**PUYALLUP DUPLEX - LOT 2**

Professional Engineer Seal for Frederick B. Brown, License No. 35710, State of Washington. Project: PUYALLUP DUPLEX - LOT 2 STORM & TESC PLAN. Client: HC HOMES INC., 7707 BONNEY LAKE, WA 98391. Date: 3/26/2024. Scale: 1"=20'. Job No.: 20069. Sheet No.: 1 of 3 Sheets. C1

**PUYALLUP DUPLEX - LOT 2**  
TESC - NOTES & DETAILS

**PUYALLUP DUPLEX - LOT 2  
NOTES & DETAILS**

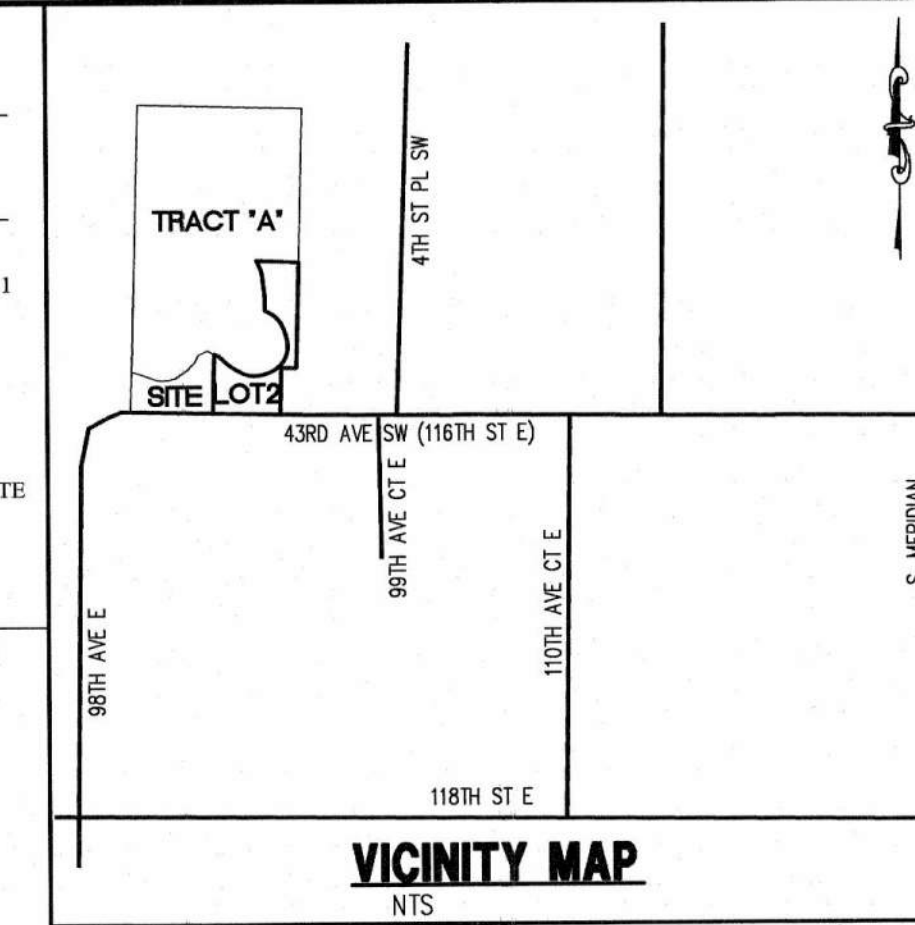
See Driveway Grading Exhibit included with approved civil plans PRCCP20240014

No dispersion trenches, pipes or other storm facilities shall be allowed in the wetland buffer without an approved mitigation plan and hydroperiod analysis. See PMC 21.06.940 (1) (c) for requirements for stormwater facilities in wetland buffers

5 ft min setback is required unless the following standards are demonstrated, then a 5ft min setback can be allowed: Five-foot minimum setback, subject to the following requirements:

(a) Entrances serving single units shall have either a minimum 50-square-foot outdoor entrance landing or an entrance threshold that is at least seven inches above the abutting sidewalk level.

(b) Entrances serving multiple units shall have an outdoor entrance landing that is at least 50 square feet per unit served by said entrance or 100 square feet, whichever is less.

(c) Entrance landings are at least three feet higher than the elevation of the street or street sidewalk level and do not extend into the required setback.

(d) Entrance steps may extend into the required setback to give visual emphasis to entries and to connect entrance landings with the right-of-way sidewalk.

(e) The area between the front or side-street lot line and the building shall be landscaped with a mixture of shrubbery and trees sufficient to achieve 75 percent ground coverage within a three-year period. At least 20 percent of the vegetation necessary to achieve required coverage shall consist of deciduous and/or evergreen trees.

PRRNSF20230918  
The applicant shall request a sediment control and erosion inspection with a City Engineering Inspector through the CityView portal at least 48 hours in advance of job start. See City Standards 02.03.02 & 05.02.01

All methods outlined in the approved stormwater report dated December 2023 must be followed in regards to erosion and sedimentation control.

All methods outlined in the approved stormwater report dated October 2023 must be followed in regards to control of downspouts and stormwater runoff.

A RECORDED COPY OF THE APPROVED STORMWATER MAINTENANCE AGREEMENT MUST BE PROVIDED TO THE CITY PRIOR TO RECEIVING A CERTIFICATE OF OCCUPANCY

All civil work associated with civil permit PRCCP20240014 must be completed prior to occupancy
